3GPP TSG_CN#6
ETSI SMG3 Plenary Meeting #6,
Nice, France
13th – 15th December 1999

NP-99443

Agenda item: 5.1.3
Source: TSG_N WG1
Title: CRs on Work Item GPRS

This document contains “22” CRs agreed by **TSG_N WG1** and forwarded to **TSG_N Plenary** meeting #6 for approval.

Figure 11: XID parameter field format

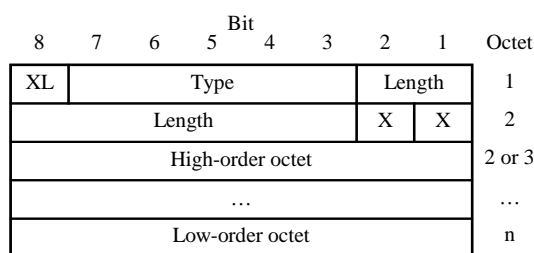
Reason for change: If an LLC process receives an XID command specifying an mU or mD value of 1 to 8, it won't be able to respond without violating the rules of XID negotiation. Specifically, either

The negotiation procedure is one-step, i.e., one side shall start the process by sending an XID command, offering a certain set of parameters from the applicable parameter repertoire (see Table 6) the sending entity wants to negotiate, proposing values within the allowed range. In return, the other side shall send an XID response, either confirming these parameter values by returning the requested values, or offering higher or lower ones in their place. As an optimisation, parameters confirming the requested values may be omitted from the XID response. See Table 6 for sense of negotiation. This shall end the negotiation process.

The responding side may respond with parameters that were not included in the XID command. A parameter that was not included in the XID command shall in this case be treated as if the current value of the parameter was included in the XID command. The responding side shall include such a parameter in every XID response until the parameter has been explicitly negotiated, either by responding to an XID command that included the parameter, or by explicitly including the parameter the next time an XID command is transmitted.

Figure 11: XID parameter field format

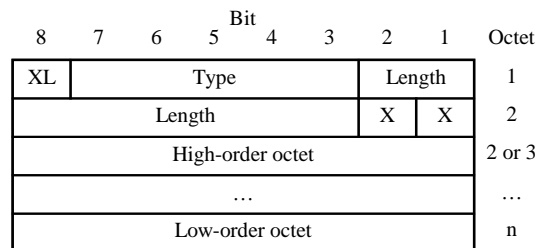
Reason for change: If an LLC process receives an XID command specifying an mU or mD value of 1 to 8, it won't be able to respond without violating the rules of XID negotiation. Specifically, either

The negotiation procedure is one-step, i.e., one side shall start the process by sending an XID command, offering a certain set of parameters from the applicable parameter repertoire (see Table 6) the sending entity wants to negotiate, proposing values within the allowed range. In return, the other side shall send an XID response, either confirming these parameter values by returning the requested values, or offering higher or lower ones in their place. As an optimisation, parameters confirming the requested values may be omitted from the XID response. See Table 6 for sense of negotiation. This shall end the negotiation process.

The responding side may respond with parameters that were not included in the XID command. A parameter that was not included in the XID command shall in this case be treated as if the current value of the parameter was included in the XID command. The responding side shall include such a parameter in every XID response until the parameter has been explicitly negotiated, either by responding to an XID command that included the parameter, or by explicitly including the parameter the next time an XID command is transmitted.
